Comment Summary

Application #: PL202400150

Request: **Preliminary and final development plans for an approximately 54,000 square foot, two-story auto dealership facility**

Meeting: Post Application DRC - August 27, 2024
Planning Commission - September 19, 2024
City Council - September 30, 2024

Figure 26 Accessible boarding area (ADA pad)

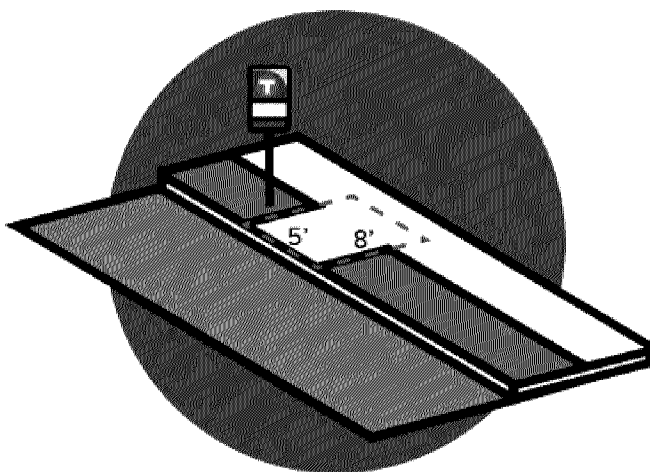
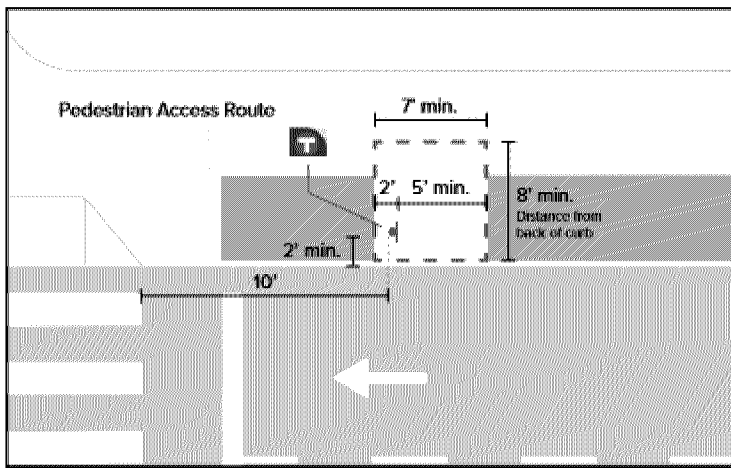
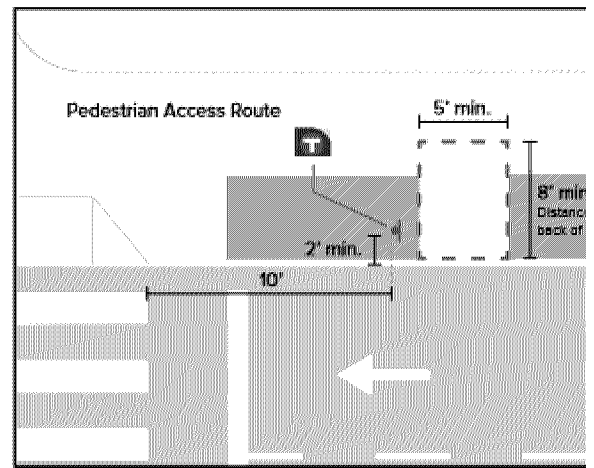
As for Metro Transit comments, we only have one stop that might be impacted by the development project. This is a westbound Route 4 stop on West 81st Street at Knox Avenue. If the project is going to reconstruct sidewalks along the southern side of the parcel, this would be a good opportunity to add an ADA pad for the stop.

As per our Regular Route Bus Stop Design guide (Figure 26), this would be a 5' wide and 8' deep firm and stable surface that connects the sidewalk to curb.

Please ask that the design team update the plans to show an ADA accessible connection between the sidewalk and curb at stop #57159. The designer should assume that stop #57159 will be kept at the same location as it is today.
